Finding: 2

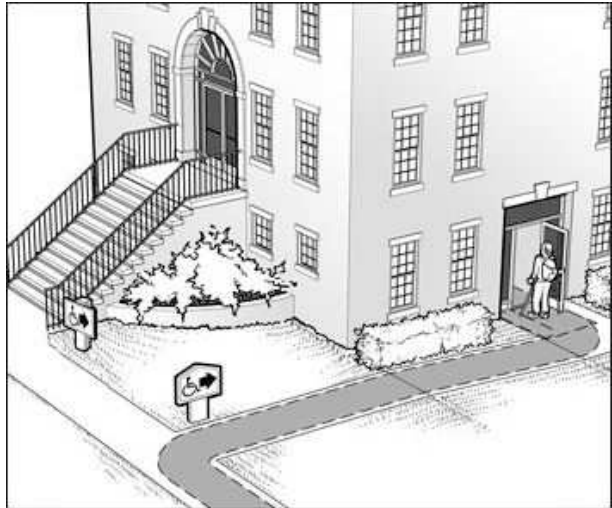
The building entrance is not located on an accessible route. The route will be a non-comporting vehicular way.

There will be no accessible route to building entrance if we create accessible parking.

Explore feasibility of creating an accessible route from the back to the front parking lot.

Finding: 3

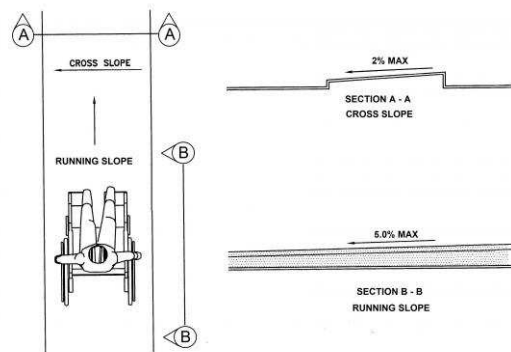
The accessible path of travel contains cross slopes greater than 2%. This sidewalk is near the driveway to the fire station parking lot.

There is 3% cross slope in this section of sidewalk.

Remove and replace the sidewalk as needed.

Finding: 4

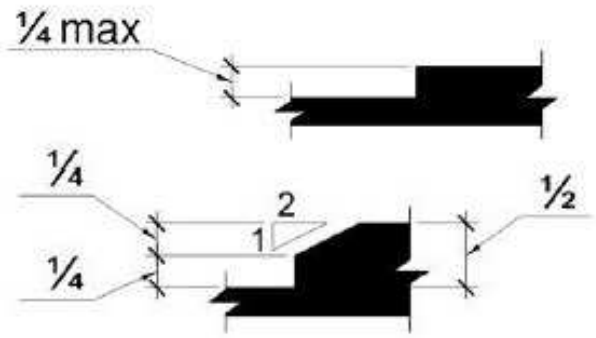
The walkway contains abrupt vertical edges and/or variations over a 1/4 inch. This section of sidewalk is adjacent to the driveway entrance to the fire station parking lot.

There is considerable spalling in this section of the section.

Remove and replace concrete panels as needed.

Finding: 5

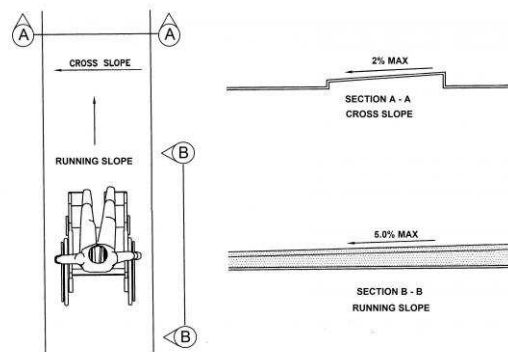
The accessible path of travel contains cross slopes greater than 2%. This sidewalk includes the driveway apron.

The sidewalk has cross slope up to 6%.

Remove and replace sidewalk as needed to achieve 2% maximum cross slope or to the maximum extent feasible.

Finding: 6

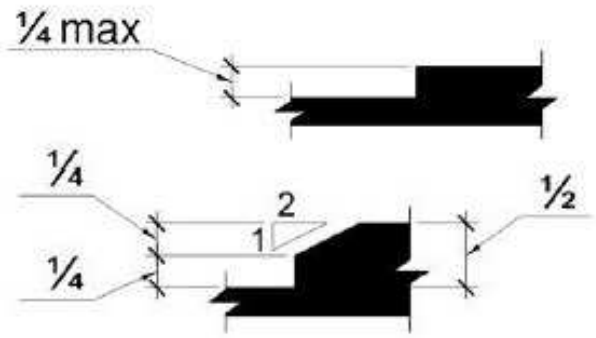
The walkway contains abrupt vertical edges and/or variations over a 1/4 inch. This is a trip hazard as well as an accessibility issue.

There is 3/4" to 2-1/2" vertical displacement at the storm drain.

Remove and replace panels as needed.

Finding: 7

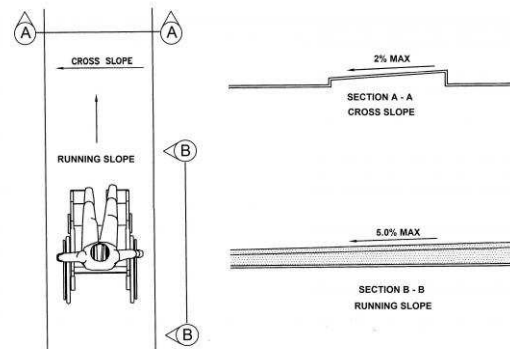
The accessible path of travel contains cross slopes greater than 2% in the driveway area.

The cross slope of this section of sidewalk is 5%.

Remove and replace concrete as needed to achieve maximum 2% cross slope.

Finding: 8

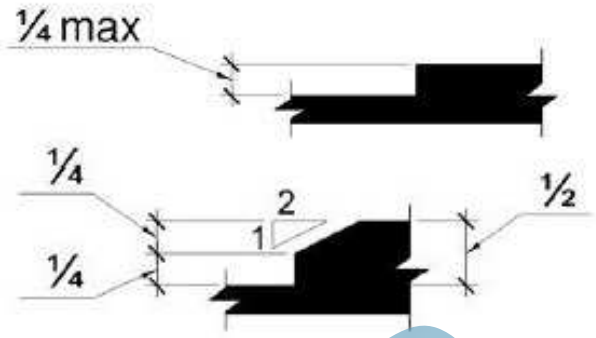
The walkway contains abrupt vertical edges and/or variations over a 1/4 inch. This is the approach to the fire station entrance. The largest section of spalling is 2" deep by 17" wide by 36" long.

There is considerable spalling in this section of the section.

Remove and replace concrete panels as needed.

Finding: 9

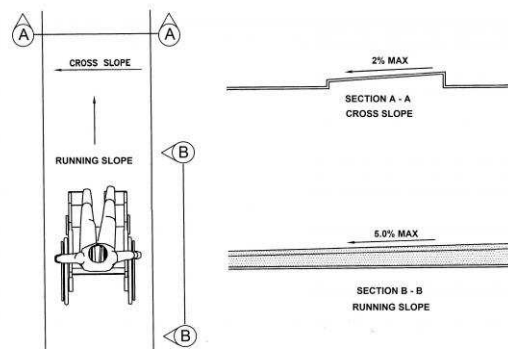
The accessible route on the site contains running slopes greater than 5% and has not been constructed as a ramp (i.e. handrails, wheel guides, etc.).

The running slope of the sidewalk to the entrance is 7%.

In lieu of making the front entrance accessible from Garden of the Gods, install a 3'-0" wide sidewalk from the entrance to the west driveway. This new sidewalk will be approximately 52'-0" long.

Finding: 10

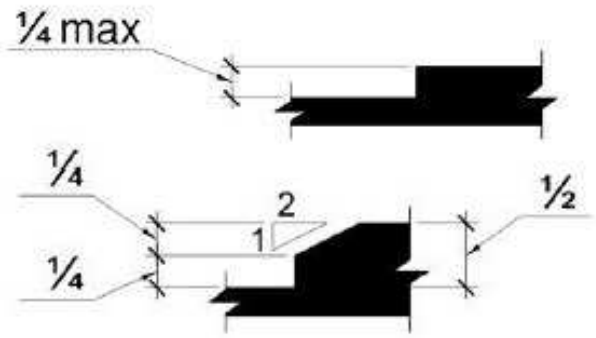
The walkway contains abrupt vertical edges and/or variations over a 1/4 inch.

An 8" core drill hole was made in the sidewalk and not properly filled.

Fill the hole or remove and replace concrete panels as needed.

Finding: 11

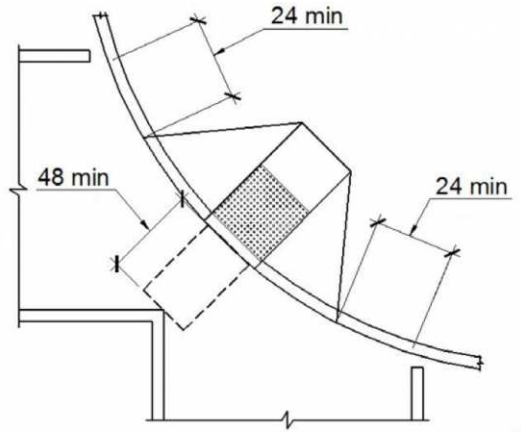
The flared sides of the curb ramp are not within the markings. The narrow entry area of this radial almost makes it a directional.

The Ramp also is missing detectable warnings.

The cross walk lines do not line up with the curb ramp.

Replace this ramp if not feasible to skew the striping.

Finding: 12

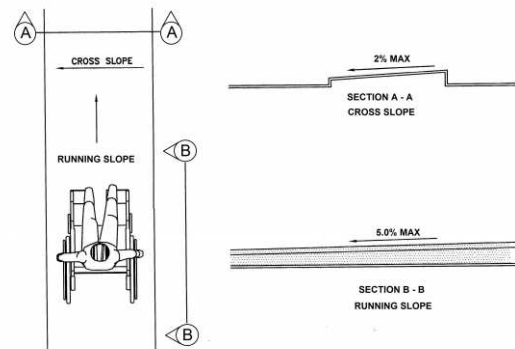
The accessible path of travel between building entrances contains cross slopes greater than 2%.

The landing at the fire station entrance has 5% cross slope.

Remove and replace concrete panel as needed to achieve maximum 2% cross slope.

Finding: 13

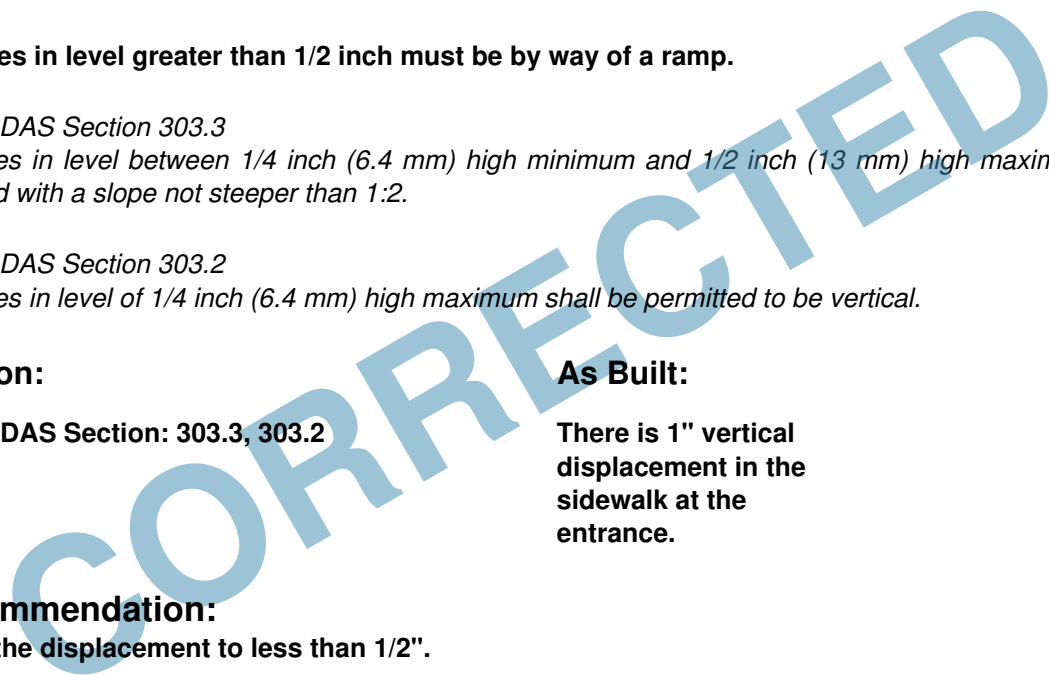
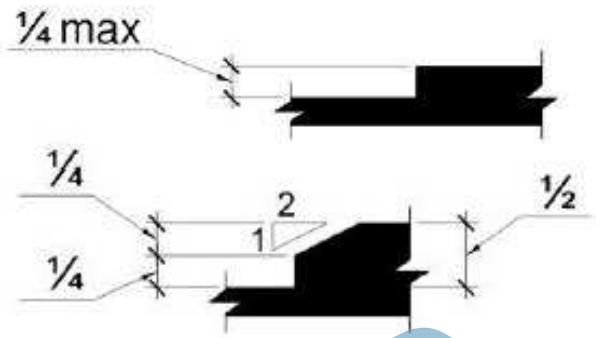
The walkway contains abrupt vertical edges and/or variations over a 1/4 inch.

There is 1" vertical displacement in the sidewalk at the entrance.

Grind the displacement to less than 1/2".

Finding: 14

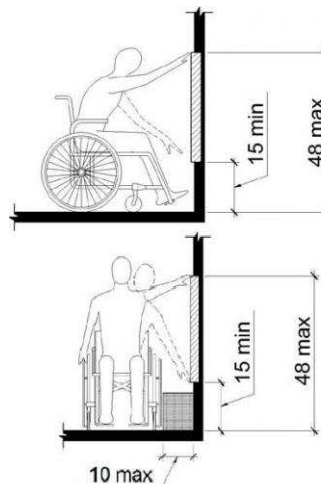
The door bell is positioned too high for either a side or front approach.

The door bell at the front entrance is mounted at 55".

Lower the door bell to 48" maximum.

Finding: 15

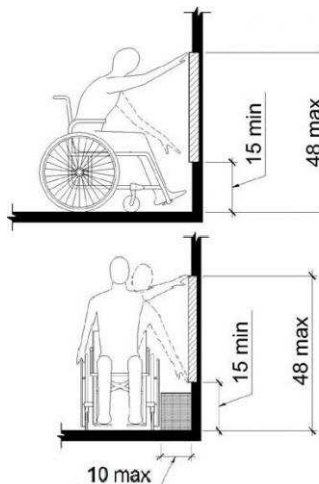
The door bell is positioned too high for either a side or front approach.

The door bell at the rear entrance is mounted at 55-1/2".

Lower the door bell if we create parking in the back and this becomes the accessible route.

Finding: 16

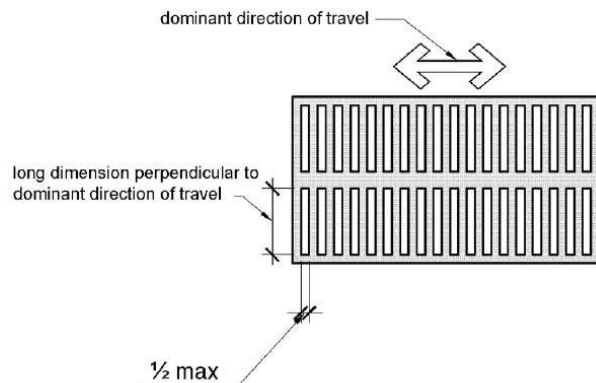
Gratings are spaced greater than a 1/2 inches in the direction of traffic flow.

The mat at the rear door has openings greater than 1/2".

Replace with a mat having openings less than 1/2" in the direction of travel.

Finding: 17

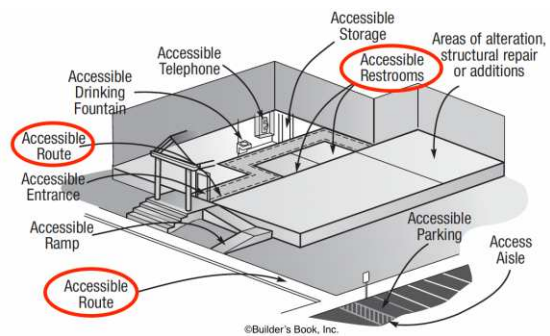
The restroom facilities serving the facility are not on an accessible route and are not accessible. There are multiple deficiencies, but these restrooms are not intended for public use.

The restrooms are not accessible.

Add signage indicating there are no public restrooms.
